Sydney North Planning Panel Meeting 21 June 2023
13-19 CANBERRA AVENUE, ST LEONARDS

Subject: 13-19 Canberra Avenue, St Leonards
Record No: DA21/162-01 - 26548/23
Division: Environmental Services Division
Author(s): Greg Samardzic

Panel Reference	PPSSNH-380
DA Number	162/2021
LGA	Lane Cove Council
Proposed Development	Section 4.55(2) modification to an approved mixed-use development
Street Address	Nos. 13 to 19 Canberra Avenue, St Leonards
Applicant/Owner	Applicant: Simon Truong - HPG General P/L Owners: SLD P/L
Date of DA lodgement	13 March 2023
Total number of Submissions Number of Unique Objections	<ul style="list-style-type: none"> • 15 • 15 • All submissions have been forwarded to the SNPP
Recommendation	Refusal
Regional Development Criteria (Schedule 6 of the SEPP (Planning Systems) 2021)	Development has a capital investment value of more than \$30 million.
List of all relevant s4.15(1)(a) matters	<ul style="list-style-type: none"> • relevant environmental planning instruments <ul style="list-style-type: none"> - SEPP 65 – Design Quality of Residential Apartment Development; - SEPP (Building Sustainability Index) 2004; and - Lane Cove Local Environmental Plan 2009. • propose

Figure 12: DRP – 2.5m Western Setback Recommendation

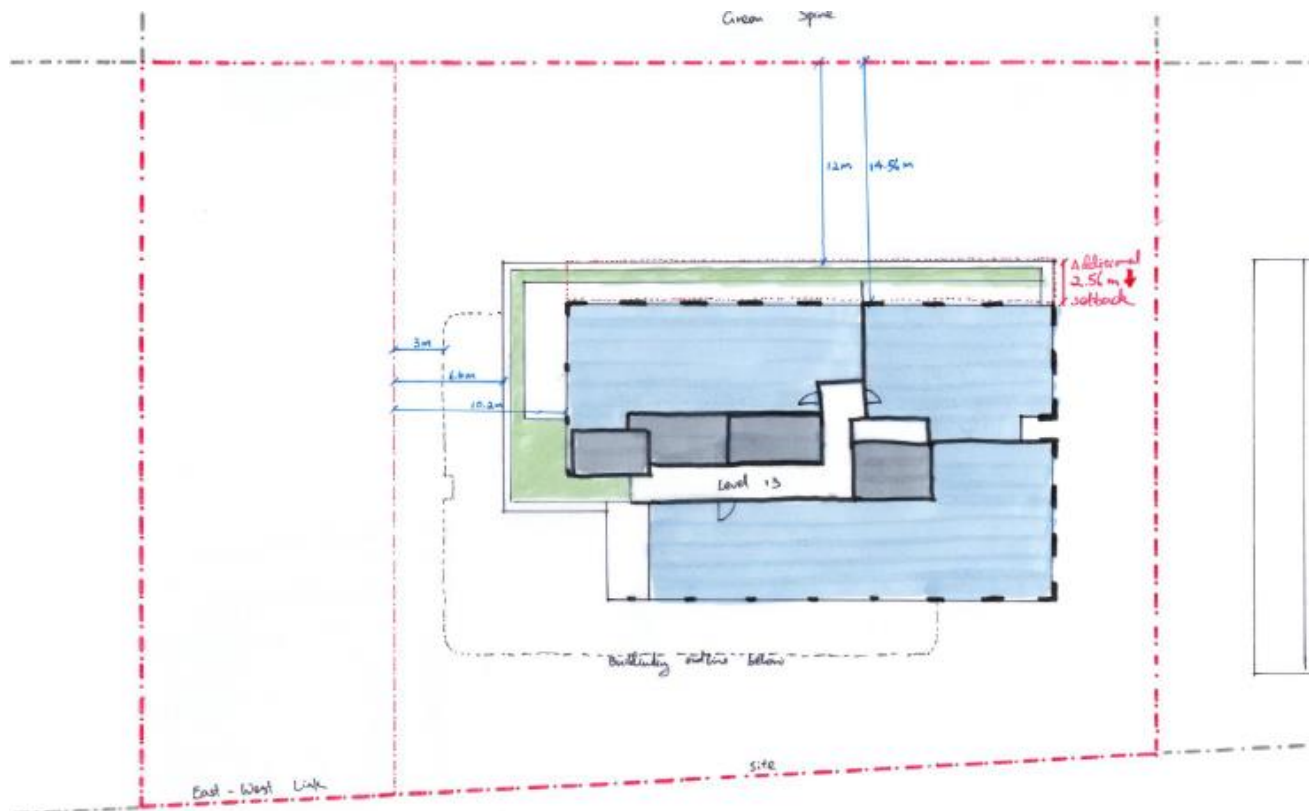
No formal design amendments had occurred however the applicant had indicated that the following design amendment would occur to address part of the Design Review Panel (DRP) concerns with the proposal as follows:

Note: Should the above design had been formally submitted, the proposal would have still been recommended for refusal due to the breaches in height and number of storeys.

Figure 16: Proposed Breach to the Maximum 44m Building Height Plane

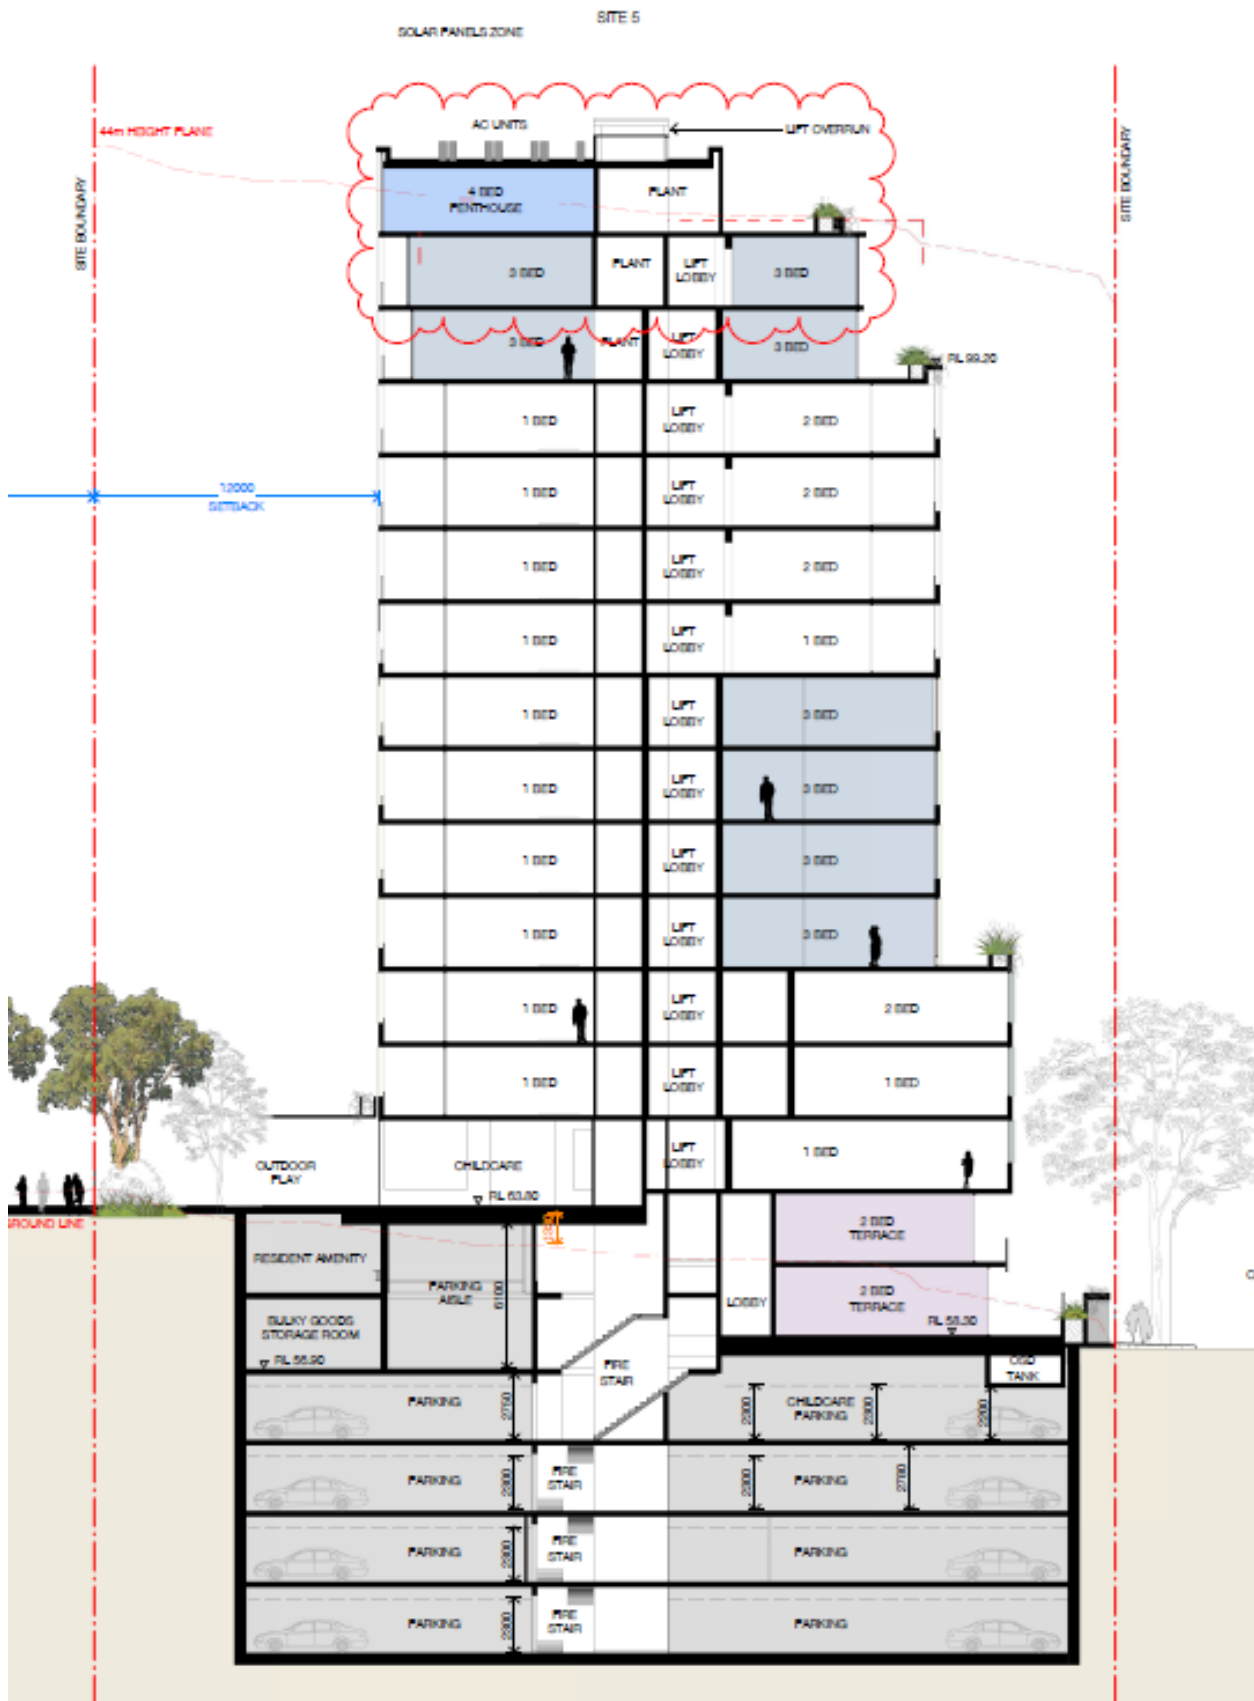
As advised above, the proposal as amended now contains a building height breach over the maximum 44m Incentive Building Height map and which would be contrary to the building height development standard under Clause 7.1(3)(a) of LCLEP 2009 (see Figure 13 above). The applicant and the panel have been advised that no approval should be granted to such a breach.

The additional visual impacts onto future adjoining developments and the additional shadow impacts onto adjoining and onto public domain areas including Newlands Park are not supported as the compliant scheme would involve a lesser impact when compared to the current scheme. To be discussed in greater detail within this report, it would be clear that the proposal would not satisfy relevant LEP objectives and there would insufficient environmental planning grounds available. Full compliance should be achieved, and the proposed two storey elements be deleted as they cannot be approved.

Figure 18 – Maximum 12 Storey DCP Control on Area 5

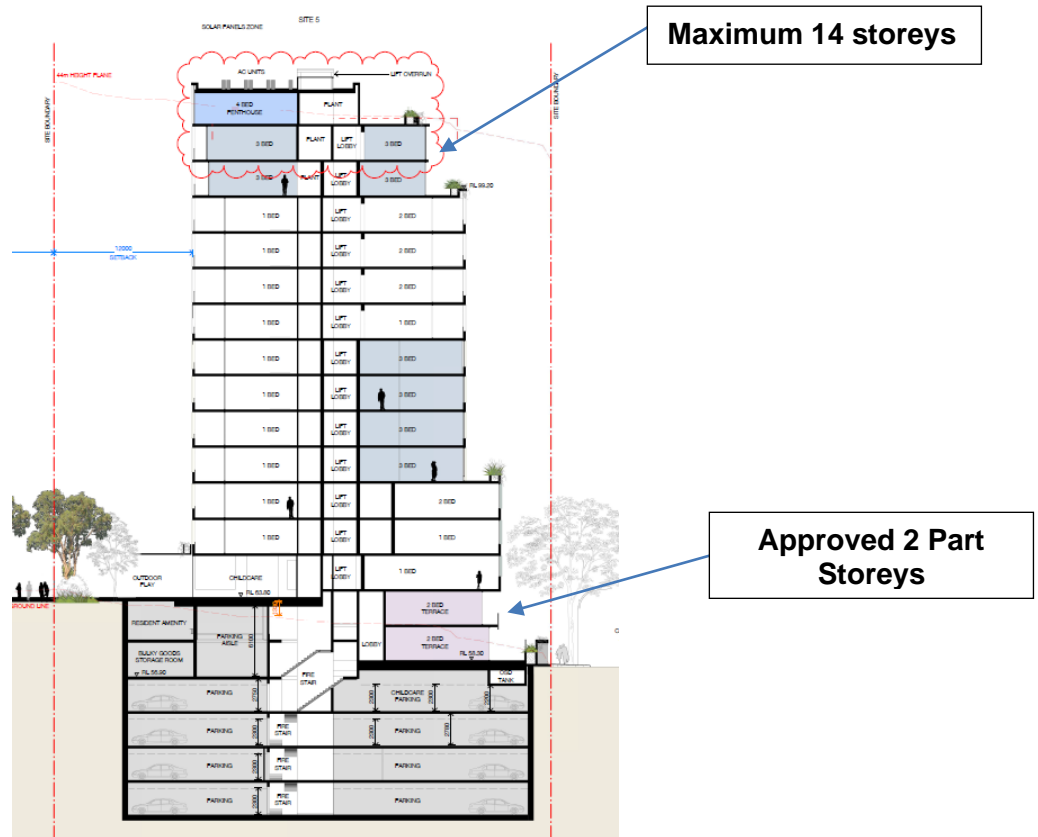
Based on the relevant ‘part storey’ definitions described above in this report and the maximum 12 storeys control, it is considered that the proposal as amended does not comply with the relevant number of storeys DCP controls. A **maximum of 14 storeys** is proposed.

The applicant has been advised that support for the proposed variation to the number of storeys would not be supported with a likely recommendation for refusal. The applicant is still seeking determination of the subject application and has provided the following justification:
